**SUBJECT: IMPLEMENTATION OF LAKES BIKEWAY**

**SUBJECT: IMPLEMENTATION OF LAKES BIKEWAY**

**PURPOSE:** To advise the Committee and Council of the results of the public consultation process for the Lakes Bikeway, and make recommendations for implementation.

**Figure 1: Lakes Bikeway Concept Used for Public Consultation**

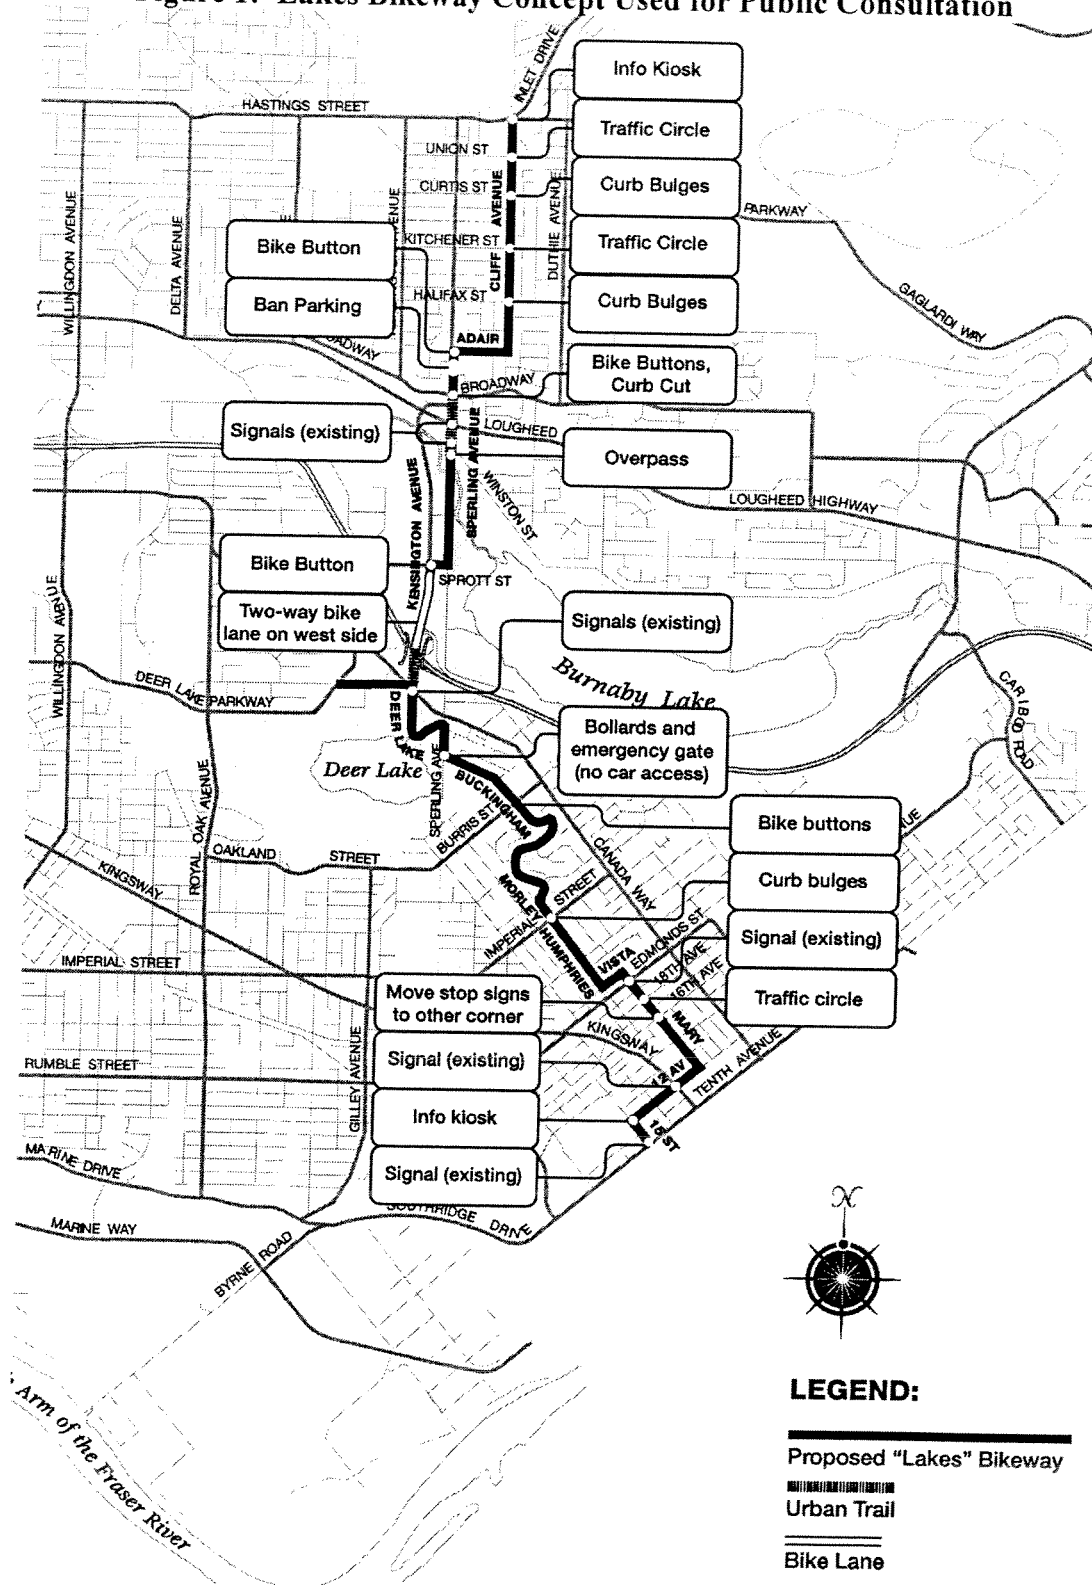
While the proposed alignment was generally viewed favourably, several respondents expressed concern about the section near Lougheed Highway, specifically from Adair in the north to the BNSF railway tracks in the south. As shown in *Figure 1*, this part of the Bikeway was proposed to follow the Sperling Avenue alignment. Concerns expressed in this area included the following, with staff comments:

- **Steepness of the grade from Lougheed Highway to Broadway.** The grade is in the order of 13%. This is difficult to do on a bicycle, and some cyclists will likely dismount and walk uphill. Potential routes with lesser grades are discussed in subsequent sections of this report.

- **Narrowness of the path from Lougheed Highway to Broadway.** As part of the Lakes Bikeway project, it is proposed to widen the existing path to 3.0 metres. This width is commonly used for Urban Trails if space is constrained. There is a short section, about 50 metres, where this widening cannot be achieved today due to insufficient right-of-way width. This will be marked as a dismount zone, and protected at the uphill end by baffles (off-set handrail sections). The City will consider obtaining additional right-of-way from the adjoining development, to allow for widening of this section in the future.

- **Steepness of the grade from Broadway to Adair Street.** This grade is on the order of 10%. While still not ideal, such a grade is not unusual for north-south bike routes in Burnaby, in view of the city's topography.

- **Conflicts with pick-up / drop-off traffic associated with Sperling Elementary School.** City staff visited the school during the morning drop-off and afternoon pick-up time periods. Curb-side activity was spread fairly evenly between Sperling Avenue and Adair Street. In either case, both sides of the street were being used. Most of the drivers are regulars, and activity was conducted in a safe and orderly fashion. The available width for cyclists is reduced at this time, but

so are vehicle speeds. The disruption is for short periods of time (on the order of 20 minutes each in the morning and afternoon) and is not considered a significant concern for cyclists.

- **Loss of on-street parking, used by parents for pick-up / drop-off at Sperling Elementary School.** There are two proposed changes to parking. On northbound Sperling Avenue, the existing parking ban during school hours would be extended to all day. This change does not affect the pick-up / drop-off activities. The only change to parking regulations that would apply during school hours would be the implementation of a no-parking zone on southbound Sperling Avenue (i.e., the west side, across the street from the school), extending southward from Adair Street for 30 metres. Stopping would still be permitted; only parking would be banned. Based on the staff observations, this area is not used heavily for parking today. During the periods observed, only three parents parked here, typically for about five minutes each. Most parents seem to avoid this area, even when space is available. With the implementation of a parking ban, the few parents who do use it would need to either:

- Park at another location, as other parents are doing.
- **Sperling Avenue is a truck route.** With the above-noted parking restrictions, cyclists will have good separation from trucks. Going northbound from Broadway, trucks may sometimes have to move from the truck lane into the through lane for a short distance, when cyclists are occupying the truck lane.

- **Potential conflicts with pedestrians in front of Sperling – Burnaby Lake SkyTrain station.** The widening of the sidewalk to 3.0 metres will increase the space available for pedestrians and cyclists. Use of this section of sidewalk is essential in order to cross the railway tracks to the south (via the overpass being constructed as part of the Central Valley Greenway).

For the above reasons, the originally-proposed routing via Sperling Avenue and Adair Street is recommended.

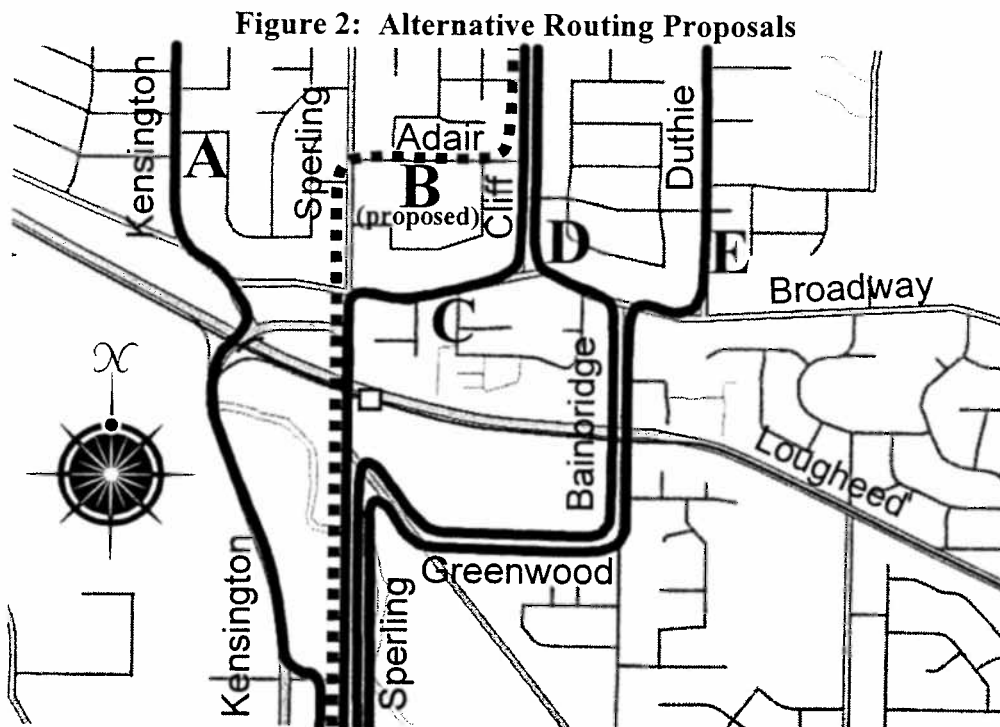
In discussing these concerns, some respondents offered alternative alignments. As shown in **Figure 2**, the options are:

- A. **Via Kensington Urban Trail to Broadway; then on-street via Broadway and Kensington.** This route also has a steep grade, on the order of 12% where it ascends to cross the railway tracks. (The Urban Trail ascends as high as the adjoining road, but in a much shorter distance. It thus has a steeper grade than the road.) There are challenges in crossing Broadway. It would also be necessary to reconstruct 300 metres of Kensington Avenue (from Curtis Street to Union Street) at considerable expense, in order to provide sufficient road width for cyclists.

Even then, traffic volumes on this part of Kensington range from 7,000 to 10,000 per day, as compared with 1,000 to 2,000 on the proposed Cliff routing. The latter is therefore seen as preferable for cyclists.

- B. Spering as originally proposed, but grade-separated above Lougheed Highway.** The intent here was to ease the 13% sidewalk grade to the north, by allowing a longer distance in which to ascend. Such a structure would descend gradually from Broadway to the south side of Lougheed Highway, ending at about the elevation of the SkyTrain platforms. In principle, if supported by TransLink, this would allow for an enhanced link to the westbound platform. However, it would then require a ramp system to get cyclists down to grade, to cross beneath the SkyTrain guideway and continue southward. The primary difficulty with this concept is one of cost. While a detailed estimate has not been prepared, the cost would likely be in excess of \$1 million. This is considered excessive for the magnitude of the problem being addressed.

- C. Spering to Broadway, then Broadway to Cliff.** The main advantage of this option is a better grade. There would still be a 13% grade south of Broadway, but the 10% grade to the north would be replaced by a 5% grade on Broadway. Difficulties are:

- The intersection of Broadway at Cliff Avenue is poor for cyclists. Due to a nearby bend in Broadway, visibility to the east is restricted. This makes it difficult for cyclists to judge when it is safe to turn left, from eastbound Broadway to northbound Cliff Avenue.

- Volumes on Broadway are somewhat higher than those on Sperling Avenue.
- To provide sufficient width for cyclists, it would be necessary to ban parking on one side of Broadway for a distance of about 300 metres, affecting a dozen homes. This contrasts with a ban of only 30 metres under the proposed concept, affecting only one home which still retains on-street parking via a side-street.

D. **Winston, Greenwood, Bainbridge, Broadway, Cliff.** This would use an existing Urban Trail on this section of Winston Street, and thereafter would be an on-street route. There are several problems with this concept:

- More circuitous. It would add 750 metres to the route length.
- Still steep. Part of Greenwood Street has a grade comparable to the 13% sidewalk grade on Sperling Avenue.
- More of the route is on higher-volume roads: Bainbridge Avenue and Broadway.
- Width. Parking bans would be required on parts of Bainbridge Avenue and Broadway. Some of Bainbridge would likely need to be reconstructed for greater width.

E. **Winston, Greenwood, Bainbridge, Broadway, Duthie.** This has many of the difficulties of the preceding option. It would also require reconstruction of Broadway, from Bainbridge to Duthie, for greater width. In addition, Duthie Avenue is a busier road than Cliff Avenue, and thus a poorer choice for the trip northward.

**Figure 3: Support for Individual Project Elements**

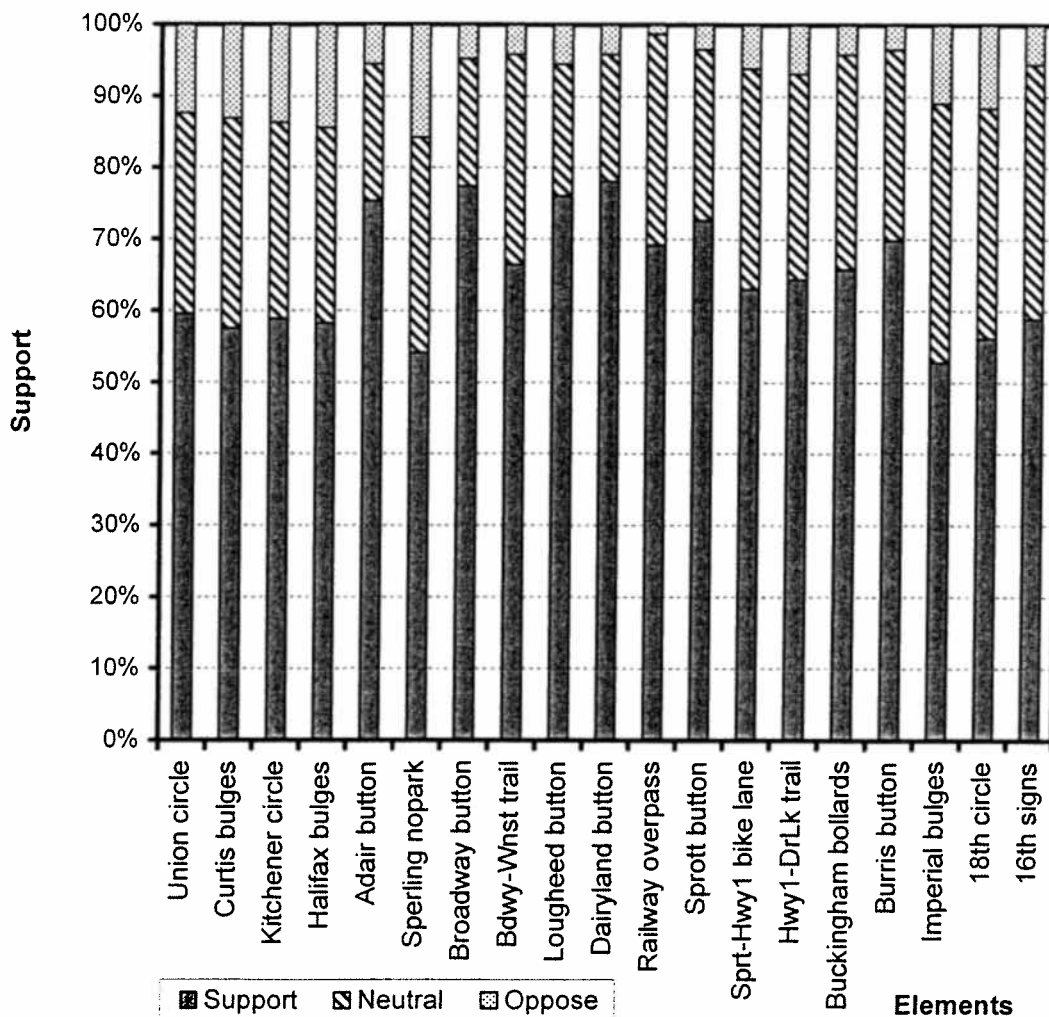
Noteworthy comments, from north to south, include:

1. **Curtis Street (at Cliff).** One of the most common suggestions was that the Bikeway should have centre median refuges rather than curb bulges at Curtis Street (and other locations). This would follow the precedent set on our other

2. **Halifax Street (at Cliff).** This is the second location where respondents suggested a centre median refuge rather than a curb bulge. The discussion given for Curtis Street applies again here, with one additional factor. There is bus service on Halifax Street, and there are bus stops in both directions at the Cliff Avenue intersection. Implementation of a centre median could mean relocating the bus stops further away from the intersection. This would be less useful to transit passengers, as well as consuming more on-street parking. The alternative would be to leave the bus stops where they are. With a centre median, this would prevent cars from passing a stopped bus. This would happen, at most, once every

3. **Adair Street to Winston Street (on Sperling).** This part of the Bikeway has already been discussed under the “routing” section of this report.
4. **Sprott Street (at Kensington).** The vehicle detector loop on westbound Sprott Street should be tuned for bicycles, and marked for cyclists. This will benefit both cyclists continuing southward on the Lakes Bikeway and those headed westward on Sprott. Staff concur with this suggestion, which will be raised with the Ministry of Transportation (owners of this signal).

5. **Sprott Street to Canada Way (on Kensington).** The crossing of the freeway was another area that generated numerous comments. In particular, the importance of maximizing the separation between motorized traffic and the proposed two-way bike lane on the west side of Kensington Avenue was noted. For example, the installation of “soft-hit” posts would provide clear separation, and discourage drivers from intruding on the bike lane. This approach has been applied successfully on Lougheed Highway, where cars regularly parked in the bike lane to access a beer store.

It was also noted that more experienced cyclists will still want to ride in the traffic on Kensington Avenue, rather than on the sidewalk. It was suggested that it may be possible to increase the on-street width available for cyclists by altering the lane markings. This would be available in addition to the proposed two-way route along the west side of Kensington Avenue.

6. **Burris Street (at Buckingham).** Vehicle detector loops should be tuned for bicycles, and marked for cyclists. Staff concur with this suggestion. This will be done in addition to the installation of the proposed bike buttons, giving cyclists a choice for how to activate this signal.

7. **Imperial Street (at Morley / Humphries).** This is another location where a proposed set of curb bulges could be replaced with a centre median refuge. However, in this case, Morley Drive to the north is offset from Humphries Avenue to the south. This requires a much larger open area in the middle of the intersection, and the value of the median is reduced. In addition, a median at this intersection would block one driveway on Imperial Street. Another suggestion was for a pedestrian / bike signal at this intersection. However, this part of Imperial Street is less busy than the western end, and a signal is not considered

8. **Edmonds Street to 16<sup>th</sup> Avenue (on Mary).** Several people suggested that the lack of sidewalks on this part of Mary Avenue is an issue. They report that there are already pedestrian / car conflicts, and are concerned that cyclists will add to this problem. In the view of City staff, cyclists will not add to the existing problem. Some existing car drivers may choose to cycle, once the Bikeway is constructed. The presence of more cyclists may also have a traffic calming effect. The existing sidewalk issue should be addressed through the Local Area Service Program. In addition, due to the linkage to the Edmonds commercial area, this section should be considered a candidate for the City's interim sidewalk program.

9. **16<sup>th</sup> Avenue (at Mary).** It was suggested that a four-way stop or traffic circle would be better than the original proposal of rotating the stop signs to favour Mary Avenue over 16<sup>th</sup> Avenue. This part of 16<sup>th</sup> Avenue is a local road (unlike the busier section to the east) and so is Mary Avenue. The rotation of the stop signs is considered a more cost-effective solution than a traffic circle, and introduces a more regular stop sign spacing on 16<sup>th</sup> Avenue. A four-way stop is not recommended, as it would still require cyclists to come to a stop for a local intersection. Accordingly, the original concept of rotating the stop signs to favour Mary Avenue is recommended.

Median refuges were considered for Curtis Street during the original development of the Bikeway concept, but were rejected out of concern that they would block one or more driveways on Curtis Street. However, it has now been determined that the medians can be implemented without blocking the driveways. Medians can either be “hollow” (as shown in **Figure 4**) or “solid”, which prohibits all left turns and the north-south through movements. The latter is considered inappropriate for Cliff Avenue, which is the only continuous local road in this area. It is therefore recommended that the Curtis Street intersection be treated with a “hollow” centre median refuge, rather than the originally-proposed curb bulges.

15 minutes during peak times. This is not considered a significant problem, particularly as this stop is not major enough to require frequent or lengthy stopping. It is therefore recommended that the Halifax Street intersection be treated with a “hollow” centre median refuge, rather than the originally-proposed curb bulges.

Staff concur with both these suggestions, and will raise them with the Ministry of Transportation (which is responsible for this part of Kensington Avenue).

appropriate. The original curb bulge concept is therefore recommended for Imperial Street.

1. The Curtis Street intersection will be treated with a “hollow” centre median refuge, rather than curb bulges.
2. The Halifax Street intersection will be treated with a “hollow” centre median refuge, rather than curb bulges.

3. Customize the vehicle detector loop for cyclists, on westbound Sprott Street at Kensington Avenue (subject to Ministry of Transportation approval).
4. Use “soft-hit” posts or other measures to enhance separation of cyclists from motor vehicles on Kensington Avenue, from Sprott Street to Highway 1 (subject to Ministry of Transportation approval).

5. Increase on-street space available for cyclists on Kensington Avenue, from Sprott Street to Canada Way (subject to Ministry of Transportation approval).

6. Customize the vehicle detector loop for cyclists, on northbound and southbound Buckingham Avenue / Drive at Burris Street (in addition to the proposed bike buttons).
